MATERIAL		DRAWN BY	Jack.Seeley	04/02/2020
THICKNESS		CUSTOMER	NEBRA (PI SUPPLY)	
www.smartboxx.co.uk		PART NO.	4497 (GA) -02	
		REV 02	SCALE: 1:2	SHEET 1 OF 1
				A4

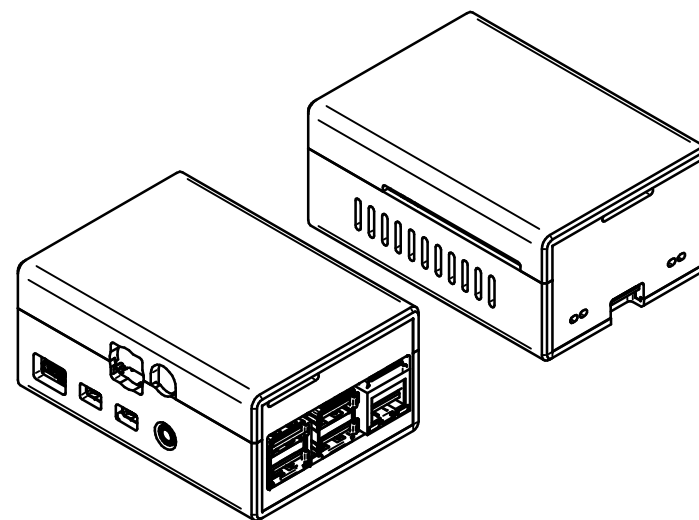
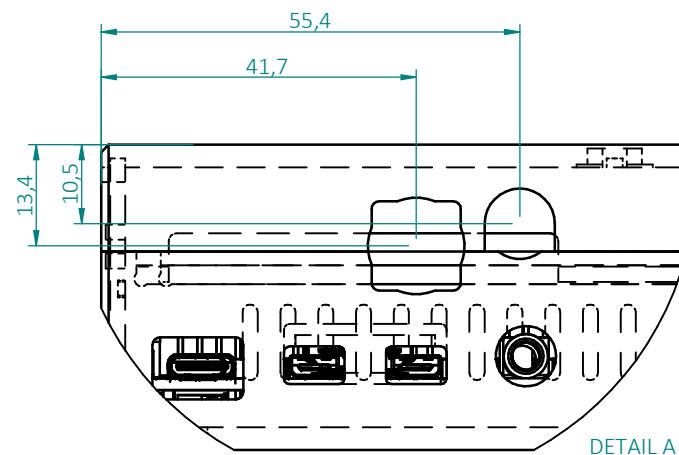
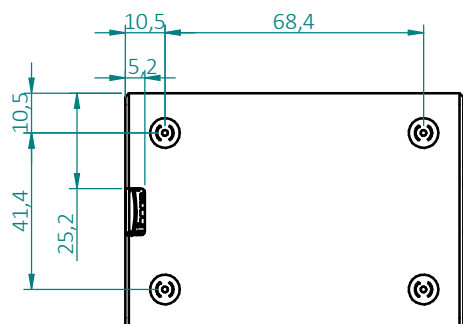
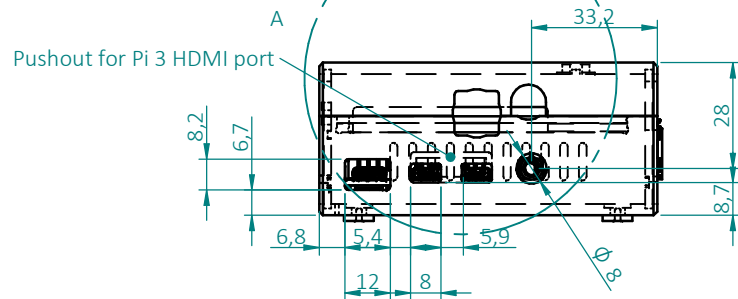
Front panel slot added to accomodate Pi 3 and Pi 4 in the end panel. This would decrease the strength of the panel so could look at bonding this to the base.
